POTRANCO MARKET
MASTER DEVELOPMENT PLAN

August 27, 2007

Re: **Potranco Market** **MDP # 022-07**

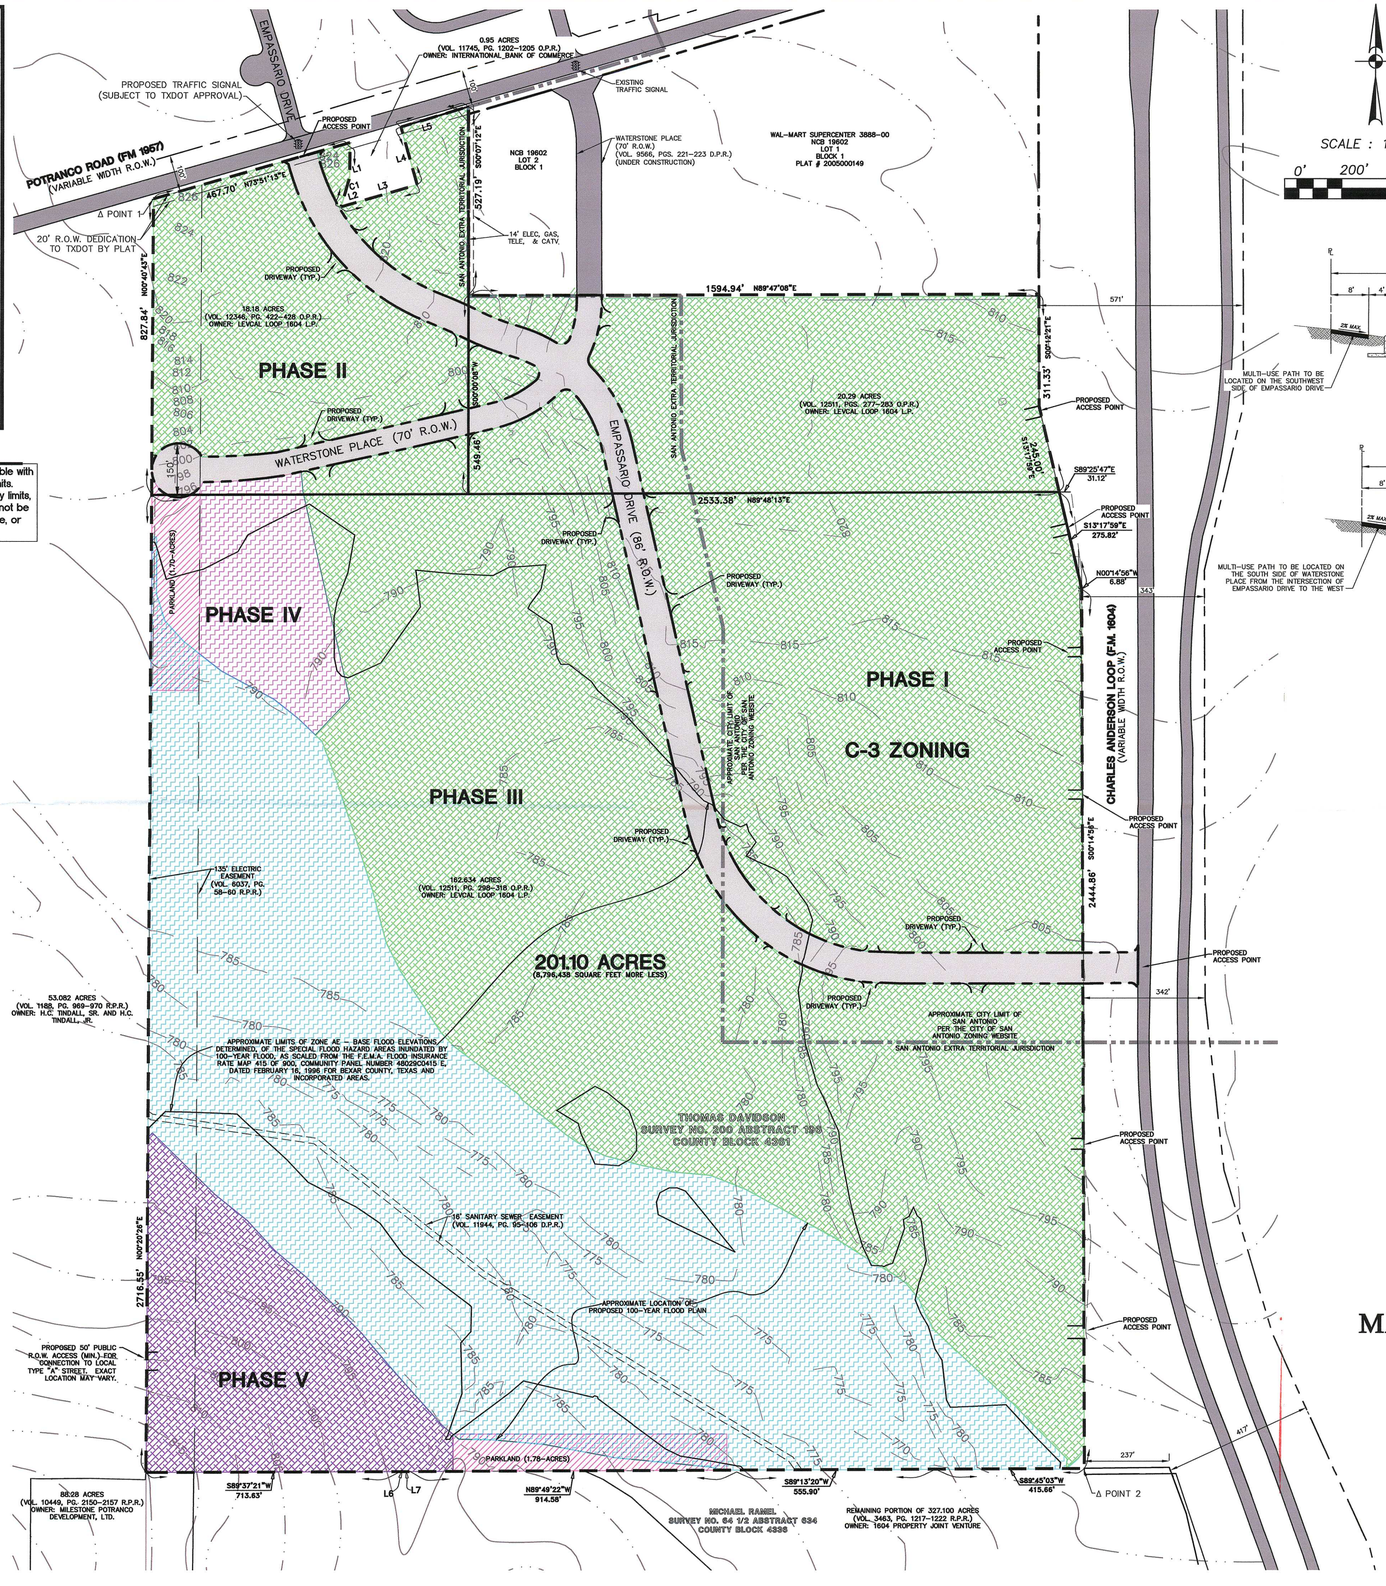
In consideration of public safety and convenience, excessive grades by reason of topography should be avoided in street layouts and arrangements. Any access and R.O.W. issues along state facilities will need to be resolved with the **Texas Department of Transportation (TXDOT)**. For information about these requirements you can contact TXDOT at 615-5814.

Historic Preservation: Staff of the HPO has reviewed the above referenced MDP. The project area has been previously surveyed for cultural resources and although one archaeological site was identified (41BX1687), further work is not necessary.

The DSD – Traffic Impact Analysis & Streets Division has reviewed the Level-3 Traffic Impact Analysis (TIA) and the MDP Plan for Potranco Market. The analysis indicates compliance with TIA Ordinance 91700 and the UDC.

The following on-site improvements, as well as, improvements along the project limits are necessary and shall be provided by the developer, on and before the completion of the development project, at no cost to the City of San Antonio:

- All commercial driveways for this project shall comply with UDC 35-506, (r) Access and Driveways.

- All access driveways shall provide clear sight distance along Empresario Drive and along Loop 1604 to provide adequate obstruction- free viewing distances for approaching traffic. All signage, landscaping, and improvements shall be selected and located so as to not block these clear sight distance areas.

- All roadways shall follow UDC 35-506 Transportation and Street Design and shall comply with UDC 35-502.

- Coordinate with TXDOT on installation of proposed traffic signal system at the intersection of Potranco Road and Waterstone Place.

- Coordinate with TXDOT on installation of recommended traffic signal system at the intersection of Potranco Road and Empresario Drive.

- Coordinate with TXDOT on the need for extending the left-turn lanes on Potranco Road through the intersection with Loop 1604 to provide additional capacity on the east-west approaches.

- Coordinate with TXDOT on the need for required roadway markings for turn lanes.

- Coordinate with TXDOT on access points along Loop 1604 (Driveways A to E).

- Provide right-turn deceleration lane for the following:

1. Southbound approach to Driveway A, B, C and D on Loop 1604 Southbound Frontage Road.
  2. Southbound approach to Empresario Drive on Loop 1604 Southbound Frontage Road.
  3. Eastbound approach to Empresario Drive on Potranco Road.

- Design all driveways along the Loop 1604 Southbound Frontage Road as right-in/right-out only driveways with appropriate signage to reduce the potential for wrong-way movements.

- Extend Empresario Drive south to Loop 1604 to provide direct access to the site.

- Extend Waterstone Place as a collector roadway between Potranco Road and Empresario drive to accommodate traffic from the retail development.

Tree Preservation: This Master Development Plan meets the criteria of the 2003 Tree Preservation ordinance (Section 35-B125 and Table 35-B101).

- 1997/2006 Tree Preservation ordinance standards per UDC Section 35-523 – a Tree Preservation Plan is required prior to any work on site. This can be submitted either as a clearing permit or at the platting stage. This project appears to be suited to a Tree Stand Delineation (30% preservation of tree canopy at MDP or 35% preservation at platting) based on the large lot sizes and tree canopy area. Note that flood plain area must be delineated separately (preserved at 80% for significant trees and 100% for heritage trees).

- Landscape ordinance per UDC Section 35-511 for area inside City of San Antonio limits. It appears some landscape points can be met by preserving existing vegetation as well as meeting any mitigation requirements (either through preservation of smaller material or transplanting). Recommend securing knowledgeable Landscape Architect at planning and design phase to better utilize existing trees and vegetation. Preservation will eliminate the need for irrigation. Staff would be willing to meet with developer at design stage to assist with tree preservation and landscape plan.

- Streetscape standards per UDC Section 35-512 – Embassario Drive and Waterstone Place required streetscape on the new ROW (recommend preservation of existing trees where available and possible).

Parks and Recreation Department: recommend approval of Potranco Market Master Development Plan with the following conditions:

Potranco Market is a proposed subdivision with 194 residential units, composed of 151 multi-family units and 43 single-family units. UDC Section 35-503, Table 503-1 states that single-family development is required to provide 1 acre of park/open space per every 70

dwelling units. The requirement for this development is 13.9 acres. This subdivision provides 24.6 acres of park/open space dedication.

- The parkland provided shall be shown as "Park" or "Open Space" on a plat; UDC section 35-503(e) *Designation of Parkland.*
- The parkland provided is dedicated to the Home Owners Association.
- The instruments creating the Home Owners Association are provided by the second application for plat approval; UDC section 35-503(e) *Designation of Parkland.*
- Parkland dedication must be platted by the second phase of residential development; UDC section 35-503(f) *Development Phasing.*
